Planning Commission
CITY HALL COUNCIL CHAMBERS
AGENDA OF OCTOBER 8, 2024
7:00 PM

**NORTH RIDGEVILLE PLANNING COMMISSION
MINUTES OF REGULAR MEETING
TUESDAY, SEPTEMBER 10, 2024**

Subject: Saint Peter Catholic Church – Parish Hall Addition – Planning Commission Submission Updates

Subject: Saint Peter Catholic Church – Parish Hall Addition – Planning Commission Submission

ROOT ROAD VACATION EXHIBIT

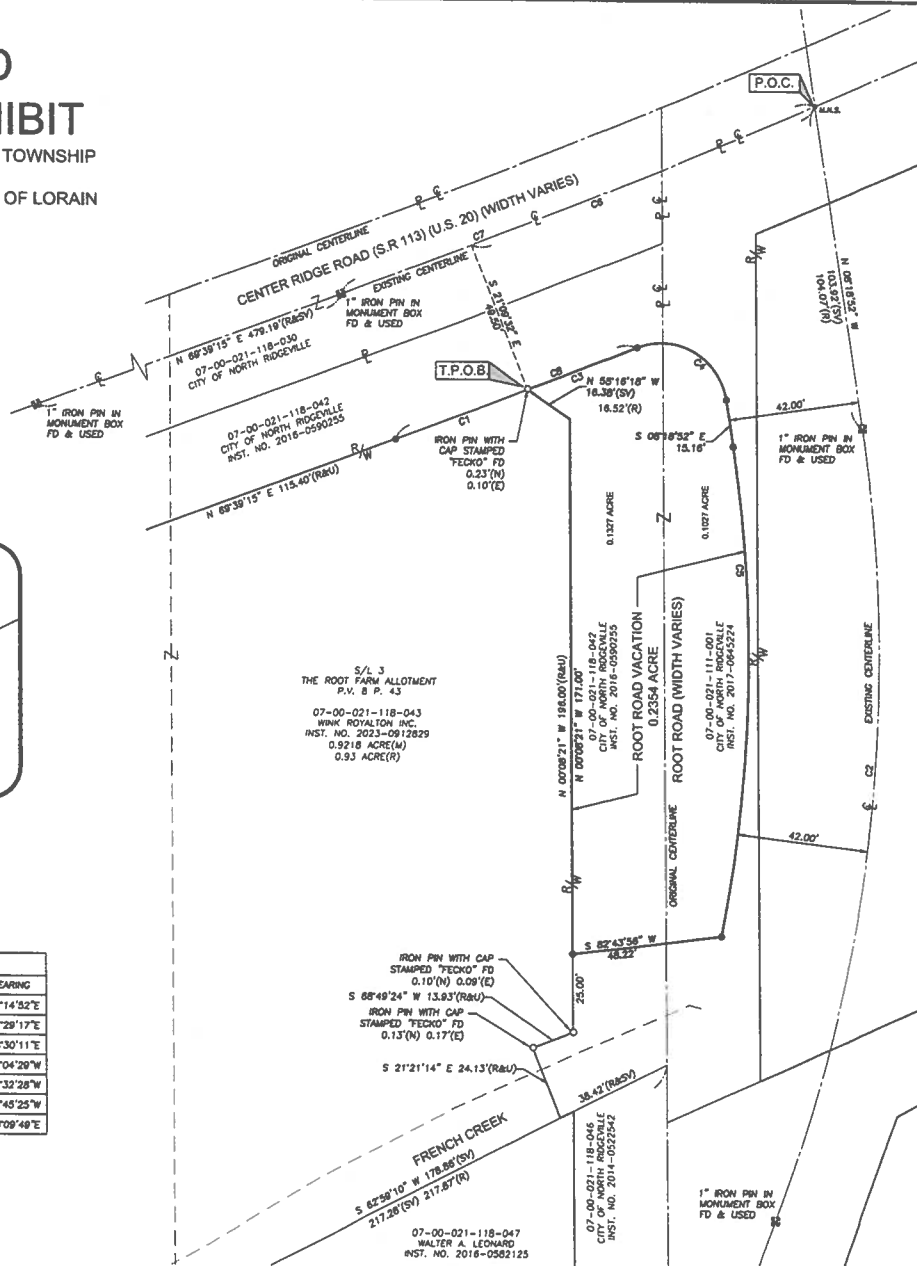
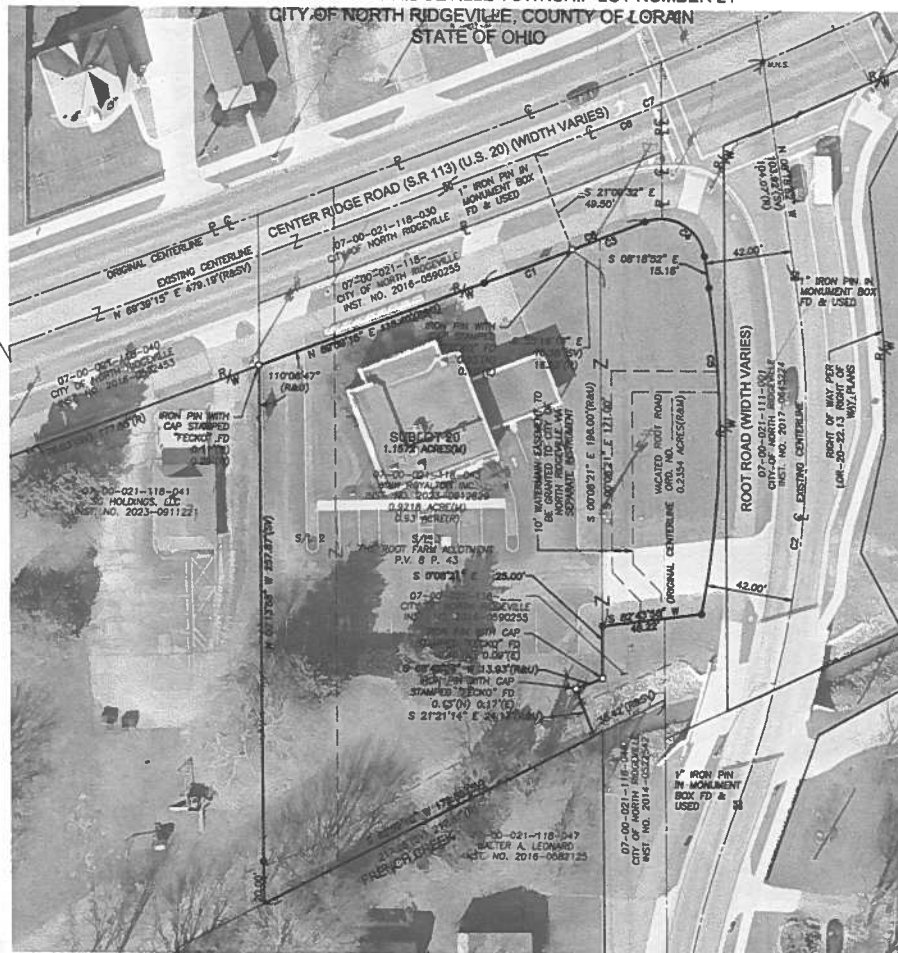
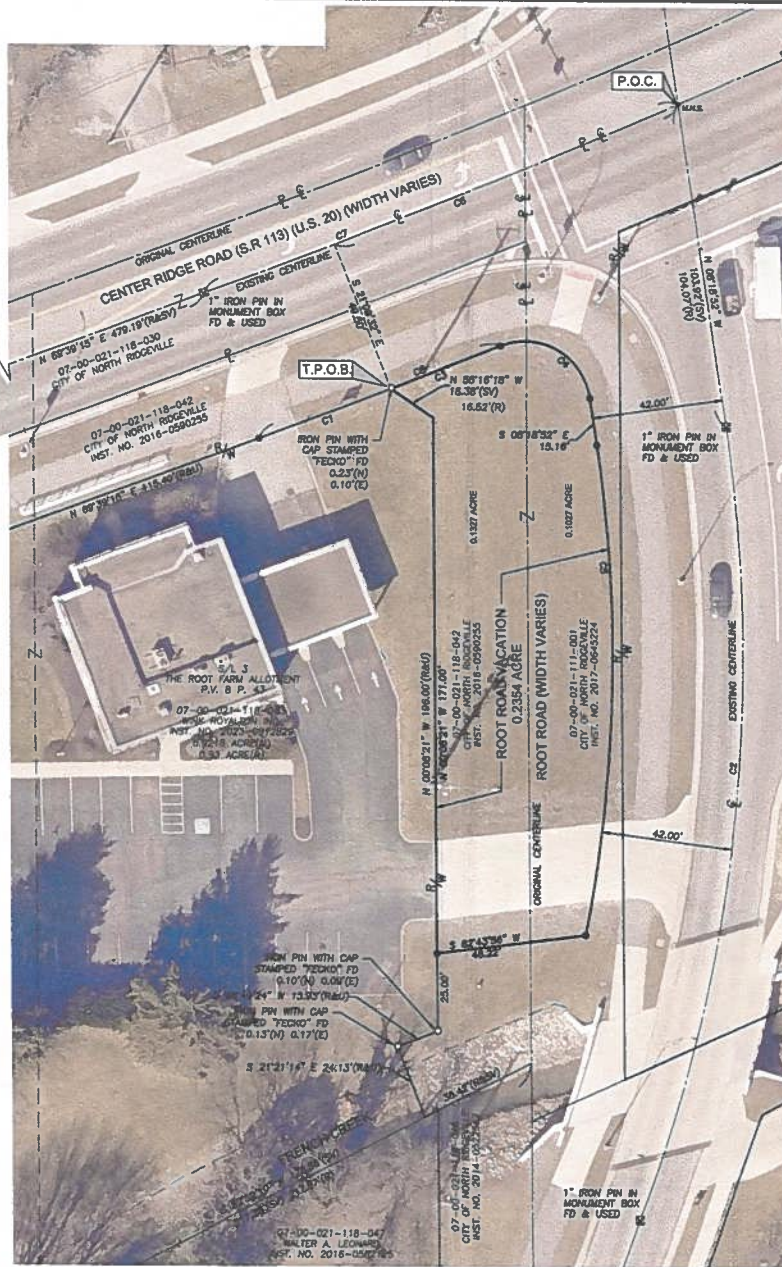
Director Lieber stated that her only comment on the street vacation would be her request that the resulting lot be consolidated with the applicant's parcel so that it didn't remain a separate parcel in the future.

- Kim stated that her concern was to protect utilities in the area.
- Christina asked what they intended to do with that piece of property in that area. Kathy stated that they didn't have any specific intention yet but that they thought it would be nice to have to be able to look at options down the road. Christina discussed that she had some concern because there was a water line and there was a large sanitary sewer. She added that she didn't know if that was reflected as she just got an as-built drawing from Fechko, but she thought it might be a little bit different than the original plan. She explained that there was a section of trunk line nearby and that she would have concerns with any kind improvement that they would want to make in that area. She stated that she would want to ensure that they had accessibility there. Kathy stated that they weren't looking to build a building and that there wasn't enough room for a building. Christina stated that she would want to limit any parking to the north side because there were so many utilities in the southern part of the vacation. She stated that there was also a guardrail for the bridge over there and some other amenities as well as the gas line and utility poles.

- Kim explained that a condition of approval would be placing an easement on the water line that would limit it to green space or parking, but no vertical and then if the City needed to get in there for any reason, the maintenance would fall back on the property owner to repair and then she would verify that the vacated area as shown did not interfere with access to the sanitary sewer and if it did, then that boundary line might be adjusted a little bit.

1 Architectural Site Plan
PC-0 Scale: 1/16" = 1'-0"

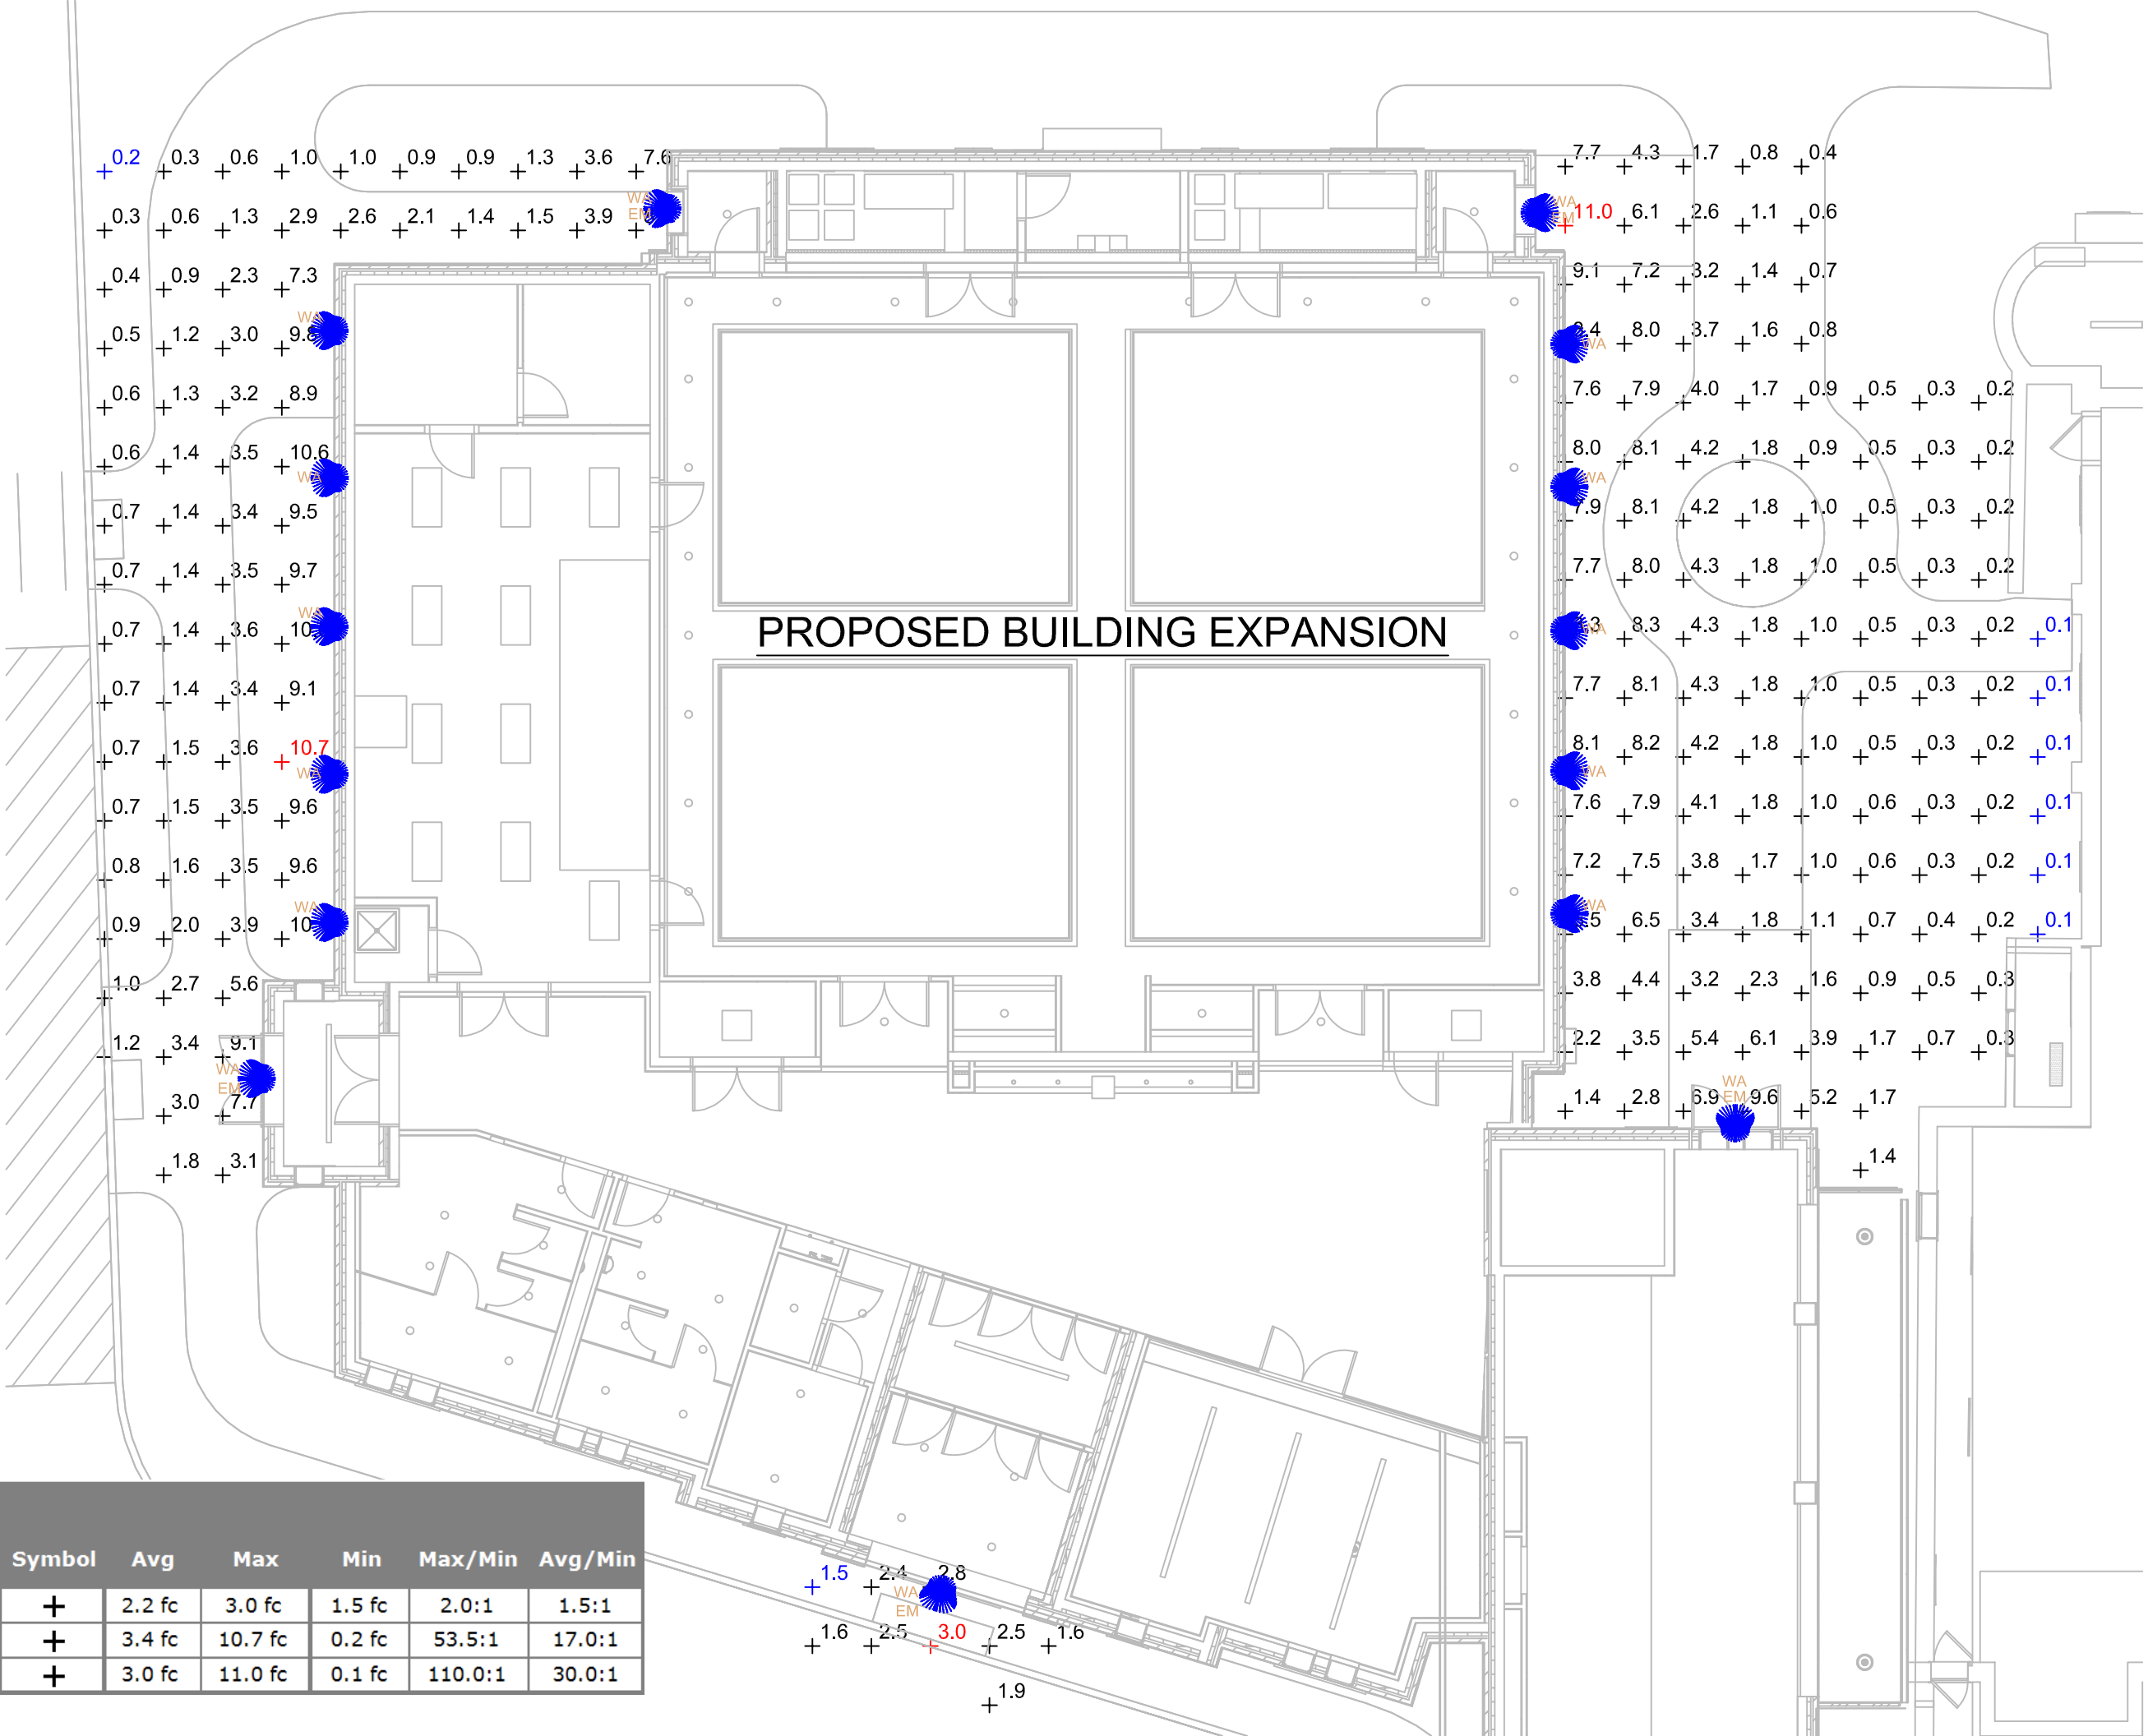
- Kim asked if they could clarify regarding the photometric if that was all new lighting or if any of it was existing. Pat stated that there was some existing pole lighting along the creek that illuminated the parking lots, and they were keeping those. He discussed that the photometric plans that she saw were building mounted lighting that would illuminate egress and entry points. Kim explained that all of their calculations were higher than what the code allowed. She explained that the allowed max average was 5-foot candle for pedestrian entrances and max any point was 12.5. Pat said they could lower lighting levels for compliance.

- Building-mounted light fixture cut sheet (Brownlee 7075 LED)
- Photometric site plan utilizing the Brownlee 7075 LED identified in the cut sheet
- PC-0: Revised architectural site plan with various dimensions along the Parish Hall Addition's northern edge in relation to the right-of-way and adjacent buildings (Gymnasium and Church), as well as a new sidewalk from the existing sidewalk along Center Ridge Road to the north façade.
- C-100: Existing Conditions and Demolition Plan
- C-200: Site Plan with revised south edge of the parking lot (note the grass filter strip)
- C-201: Pavement Marking Plan with revised south edge of the parking lot (note the grass filter strip)
- C-300: Grading Plan with revised south edge of the parking lot (note the grass filter strip)
- C-400: Utility Plan with revised south edge of the parking lot (note the grass filter strip)
